BRASWELL ENGINEERING, INC.

Comments and Additional Information

Appeal Resolution for Congaree River in Richland and Lexington Counties, S.C.

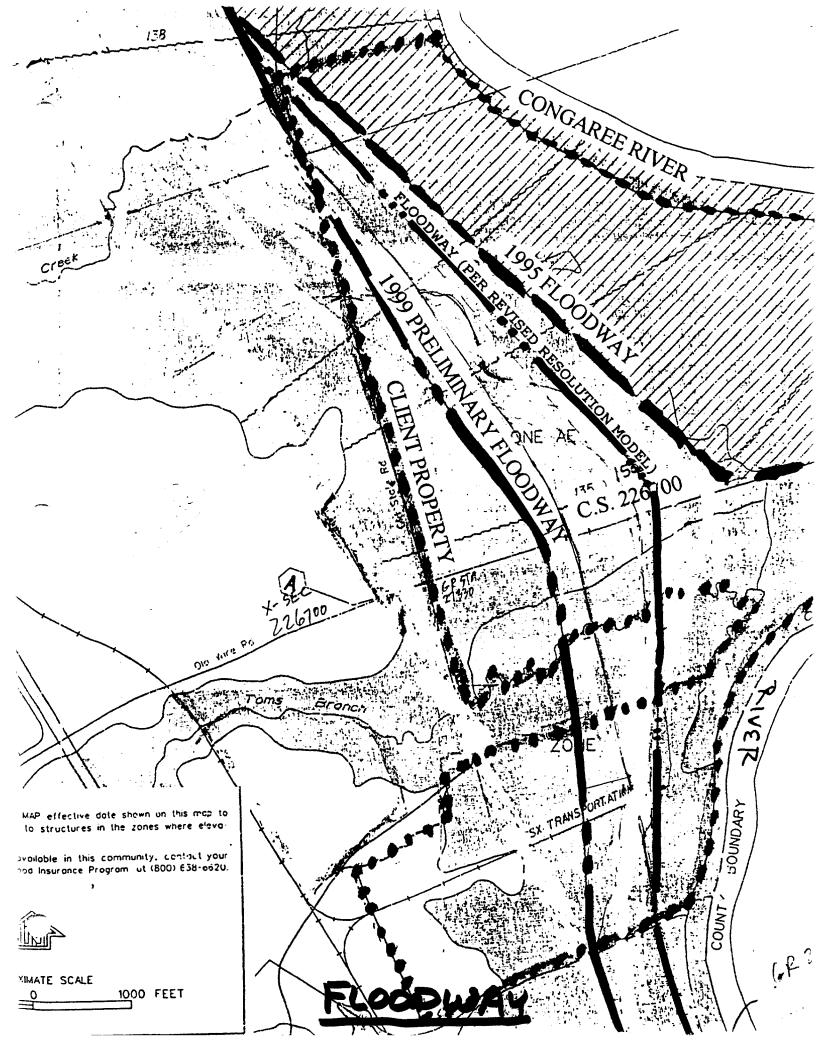
At the request of FEMA representatives and in support of the original appeal request, photographs were made of the Congaree River floodplain conditions within the right overbank area of Cross Section "A" (226700) in Lexington County. The photographs, along with their descriptions and a map showing their location, are contained within the appendix of this report. The photographs clearly support the previous assumption, that the "n" value of 0.03 used in the NH data between GR stations 25101 and 30259.4 was not representative of the existing composite floodplain conditions and that a weighted average value of 0.09 would provide an accurate portrayal of the site. The higher "n" value would also be more consistent with the overbank values used to model upstream and downstream cross sections.

The HEC-2 floodway data for the Congaree River provided and dated October 18. 2000 was revised using the 0.09 value on the NH line between Stations 25101 and 30259.4 at Cross Section 226700. The revised model resulted in a narrower floodway at C.S. 226700 with only a slight increase in the 100-year and floodway elevations above the current (10/18/00) FEMA model. The increase in elevations averaged from 0.1 feet to 0.0 feet from the site upstream to the end of the study reach. The allowable increase in the 100-year elevation due to the floodway encroachment was well below the FEMA and South Carolina maximum of 1.00 foot. An additional change to the model was made which involved revising the encroachment limit on the ET line at C.S. 226700 from 5.41 to 7.41. This change resulted in an efficient floodway while maintaining floodway elevation increases below the 1.00 foot maximum throughout the study reach. This revised floodway model resulted in no significant changes in floodway widths upstream or downstream of C.S. 226700. The average floodway velocities at the section were just over 2 fps with lower velocities out in the overbank areas. With these low velocities, the slight bend in the floodway configuration would have little or no impact on the system. The proposed floodway configuration is shown on the following copy of a portion of the FEMA map.

Revising the "n" value at Cross Section "A" would not only provide a more accurate representation of existing conditions but also provide a value more consistent with the adjoining modeled cross sections. By revising the "n" value and fine tuning the encroachment limits, an efficient and viable floodway consistent with FEMA and South Carolina requirements would result.
